### AGENDA

### PLANNING & ZONING COMMISSION REGULAR MEETING TUESDAY, MAY 19, 2020 - 3:30 PM MCALLEN CITY HALL, 1300 HOUSTON AVENUE CITY COMMISSION CHAMBERS, 3<sup>RD</sup> FLOOR

- a) Gepetto Meadows Subdivision; 16701 North Eubanks Road- Christopher Ross (Final) (SUB2020-0030) MAS
- b) Only Love Subdivision; 5500 North 29th Street Cynthia Ann Salazar (Revised Preliminary) (SUB2020-0032) MGE
- c) Shary Manor Subdivision; 7000 North Shary Road Shary 80 Phase I, LLC (Preliminary) (SUB2020-0025) JHE
- d) Avanti Legacy Subdivision; 220 South 1st Street Frank A. Smith Sales, Inc. (Preliminary) (SUB2020-0028) CE

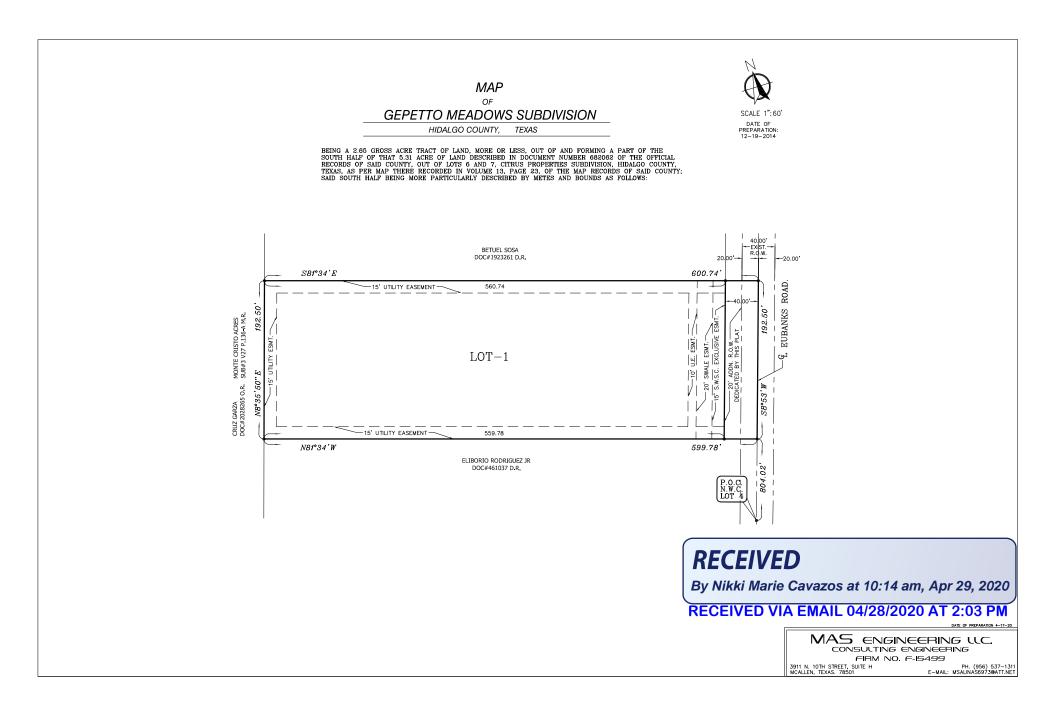
SUBDIVISION NAME: GEPETTO MEADOWS	
REQUIREMENTS	
STREETS AND RIGHT-OF-WAYS	
Eubanks Rd 20 ft. additional ROW dedicated for 40 ft. Centerline - 80 ft. ROW Paving: 52 ft. Curb & gutter: Both sides *Must escrow monies if improvements are not constructed prior to recording. **Show total ROW on plat after accounting for ROW dedication	Applied
10 1/2 Mile Rd 40 ft. for centerline - 80 ft. ROW Paving: 52 ft. Gutter: both sides *Engineer provided map showing future 10 1/2 Mile Rd. will not affect the proposed subdivision.	NA

* Garage: 18 ft. except where greater setback is required	Applied
*ALL SETBACKS ARE SUBJECT TO INCREASE FOR EASEMENTS OR APPROVED SITE PLAN	Applied
SIDEWALKS

* 6 ft. opaque buffer required from adjacent/between multi-family residential and commercial, and industrial zones/uses	Applied
* 8 ft. masonry wall required between single family residential and commercial, industrial, or multi-family residential zones/uses	Applied
*Perimeter buffers must be built at time of Subdivision Improvements.	Applied
NOTES

SUBDIVISION NAME: ONLY LOVE HOME CARE	
REQUIREMENTS	
STREETS AND RIGHT-OF-WAYS	
Dove Ave.: min. 30 ft. dedication for 75 ft. from centerline for 150 ROW Paving: min. 65 ft. Curb & gutter: both sides **Show centerline and 75 ft. from centerline on the plat, prior to final.	Applied

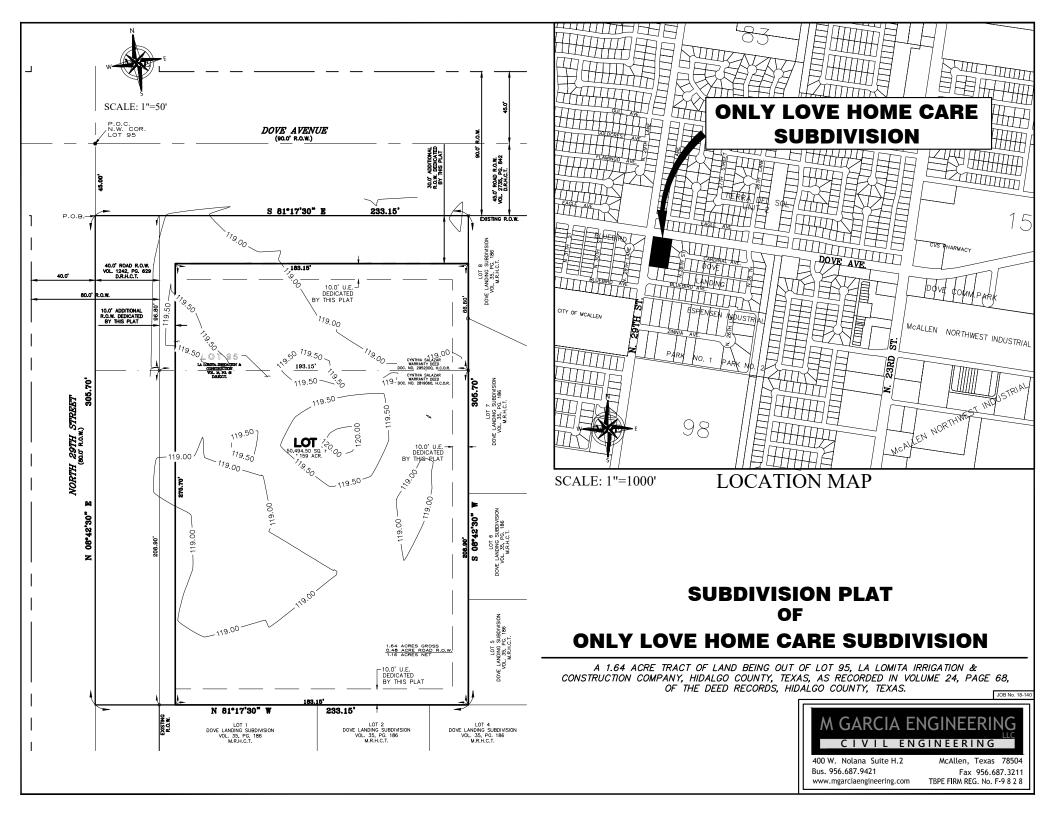
N. 29th Street: min. 10 ft. dedication for 50 ft. from centerline for 100 ft. ROW Paving: 65 ft. Curb & gutter: both sides **Show centerline and 50 ft. ROW from centerline on the plat, prior to final.	Applied
Paving Curb & gutter	Applied

* Rear: In accordance with the Zoning Ordinance, or greater for easement. **Plat submitted May 12, 2020, shows 10 ft. for rear setback, need to revise prior to final.	Non-compliance

* Sides: In accordance with the Zoning Ordinance or greater for easements. **Plat submitted May 12, 2020 needs to be revised as noted above.	Non-compliance

* Garage: **Plat submitted May 12, 2020 needs to be revised to remove garage setback reference.	NA
*ALL SETBACKS ARE SUBJECT TO INCREASE FOR EASEMENTS OR APPROVED SITE PLAN	Applied
SIDEWALKS

BUFFERS	
<ul> <li>* 6 ft. opaque buffer required from adjacent/between multi-family residential and commercial, and industrial zones/uses.</li> <li>**Note #7 on plat submitted May 12, 2020 needs to be revised as noted above.</li> </ul>	Non-compliance
<ul> <li>* 8 ft. masonry wall required between single family residential and commercial, industrial, or multi-family residential zones/uses.</li> <li>**Plat submitted May 12, 2020 needs to be revised to reflect this requirement.</li> </ul>	Non-compliance
*Perimeter buffers must be built at time of Subdivision Improvements.	Applied
NOTES

Comments: Must comply with City's Access Management Policy. **Traffic Department, Fire Department and Public Works have indicated they need a site plan for review. ****Engineer submitted a variance request on May 12, 2020 for the proposed setbacks shown on plat.	Applied
RECOMMENDATION	
Recommendation: STAFF RECOMMENDS APPROVAL OF THE SUBDIVISION IN REVISED PRELIMINARY FORM, SUBJECT TO CONDITIONS NOTED AND CLARIFICATION ON THE REQUESTED VARIANCES.	Applied

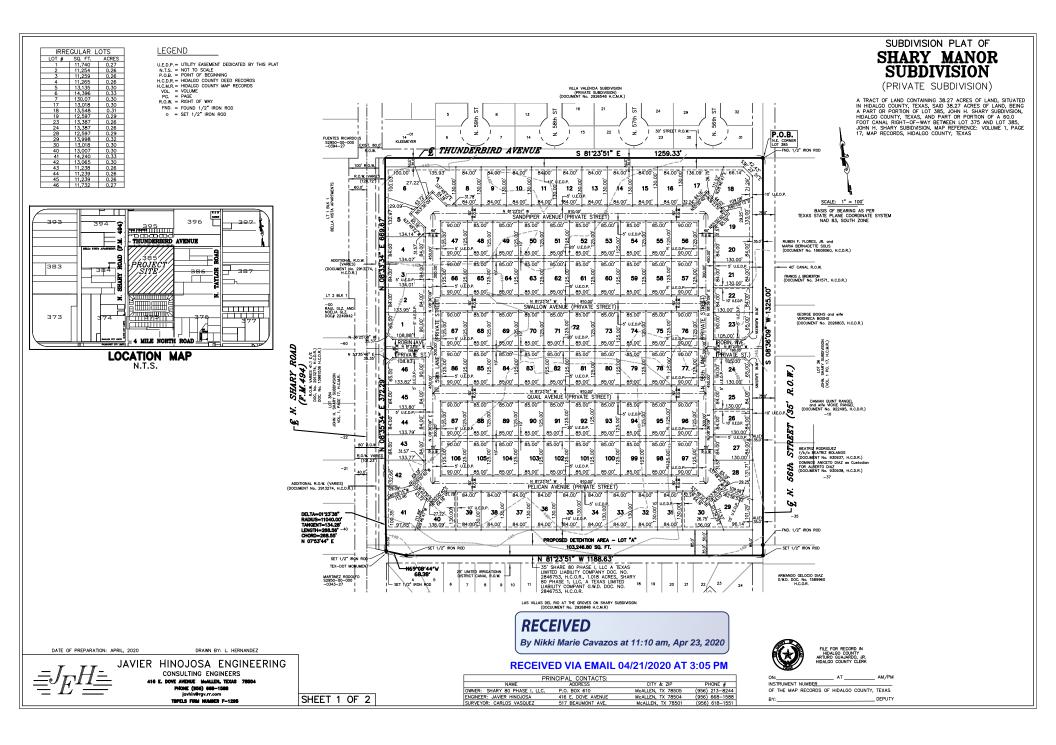
SUBDIVISION NAME: SHARY MANOR REQUIREMENTS	
North Shary Road: 60 ft. from centerline for 120 ft of ROW Paving: by the state Curb & gutter: by the state *Provide copy of document for ROW dedication (Doc. #2913274) **Provide range of dedication along North Shary Road, including ROW from centerline to new property line to verify if additional dedication required prior to final.	Non-compliance
Thunderbird Avenue: 30 ft. dedication from centerline for 60 ft. ROW Paving: 40 ft. Curb & gutter: both sides **Must escrow monies if improvements are not built prior to recording. ***Correct plat to indicate 30 ft. additional ROW dedicated by this plat. ****Tervise reference to an alley where ROW is being dedicated.	Non-compliance
Robin Avenue (entrance Streets): 60 ft. ROW Paving: 40 ft. Curb & gutter: both sides *Escrow monies if improvements not built prior to plat recording. **Provide gate details prior to final to assure compliance with requirements.	Applied

Other Interior Streets: 60 ft. ROW Paving: 40 ft. Curb & gutter: both sides **Engineer must clarify use prior to final. As per application, R-3A zones require 60 ft. of ROW with 40 ft. of paving. 50 ft. of ROW is being proposed. **As per Engineering Department, Square knuckles, in lieu of round cul-de-sacs, may pose an issue with placement of inlets in the future and are therefore not recommended. ***Must escrow monies if improvements are not built prior to final. ****As per Fire Deptartment, Cul-de-Sac minimum of 96 ft. paving diameter face-to-face.	Non-compliance
<ul> <li>N. 56th Street: 35 ft. ROW dedication for 70 ft. ROW</li> <li>Paving: 50 ft. Curb &amp; gutter: both sides</li> <li>*Clarify "35 ft. Alley" indicated on the North 56th. St. ROW.</li> <li>**Indicate the total and dedicated ROW on North 56th St.</li> <li>***City Commission approved a variance request to allow a half street with 24 ft. of paving at their meeting of March 27, 2017. Variance will be applied to this subdivision.</li> <li>****Escrow monies if improvements not built prior to plat recording</li> <li>******Revise reference to alley where ROW is being dedicated.</li> </ul>	Non-compliance

* 600 ft. Maximum Cul-de-Sac. **As per Engineering Department, Square knuckles, in lieu of round cul-desacs, may pose an issue with placement of inlets in the future and are therefore not recommended. ***As per Fire Department, 96 ft. minimum diameter face-to-face for Cul-de-Sac	Applied
ALLEYS	
ROW: 20 ft. Paving: 16 ft. *Alley/service drive easement required for commercial properties. **Clarify use/zone prior to final and reference on plat to alleys where streets are located; Thunderbird Avenue and North 56th Street.	TBD

SETBACKS	
* Front: 20 ft. or greater for easements. ****Please revise plat Note #3 as shown above.	Non-compliance
<ul> <li>* Rear: In accordance with the Zoning Ordinance or greater for easements.</li> <li>**Please revise plat Note #3 as shown above.</li> </ul>	Non-compliance
<ul> <li>* Sides: In accordance with the Zoning Ordinance or greater for easements.</li> <li>**Please revise plat Note #3 as shown above.</li> </ul>	Non-compliance

**Engineer must verify use and zoning before final to determine what type of buffer will be required.	
<ul> <li>* 8 ft. masonry wall required between single family residential and commercial, industrial, or multi-family residential zones/uses.</li> <li>**Engineer must verify use and zoning before final to determine what type of buffer will be required</li> </ul>	TBD
required. *Perimeter buffers must be built at time of Subdivision Improvements.	Applied
NOTES

<ul> <li>* Minimum lot width and lot area,</li> <li>**Lots 6, 18, 29, 41 do not have the required minimum 50 ft. of frontage along a street. Please revise plat and verify that all lots comply with minimum frontage prior to final.</li> </ul>	Non-compliance
ZONING/CUP

#### SUBDIVISION PLAT REVIEW

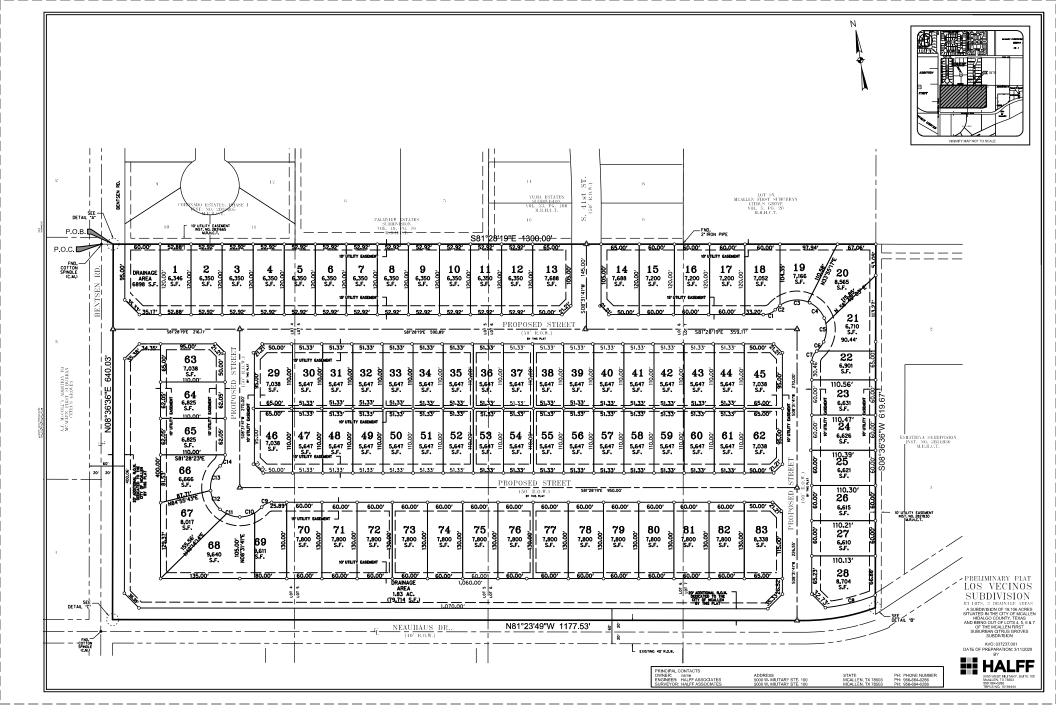
* 600 ft. Maximum Cul-de-Sac	NA
ALLEYS	
ROW: 20 ft. Paving: 16 ft. *Alley/service drive easement required for commercial properties	NA
SETBACKS	
<ul> <li>* Front: 25 ft. or greater for easements.</li> <li>**Clarify reference to 30 ft. setback on Bentsen Road and 40 ft. on Neuhaus Drive, Note will be finalized prior to final once this has been clarified.</li> </ul>	Applied
<ul> <li>* Rear: In accordance with the Zoning Ordinance, or greater for easements, except 25 ft. for double fronting lots as may be applicable.</li> <li>**Note #5 to be revised once established, prior to final.,</li> </ul>	Applied

* Interior sides: In accordance with the Zoning Ordinance, or greater for easements.	Compliance
* Corner: 10 ft. or greater for easements. **Revise Note #5 as noted above.	Applied

* Minimum lot width and lot area. Plat submitted January 7, 2020 shows that some lots appear to have less than the required lot frontage width. Verify that all lots meet minimum 50 ft. wide frontage requirement with corner lots minimum 54 ft. frontage for R-1 zone requirements, prior to final.	Non-compliance
ZONING/CUP	
<ul> <li>* Existing: R-1 Proposed: R-1</li> <li>**Not all lots appear to meet minimum requirements; revise plat as needed.</li> </ul>	Applied
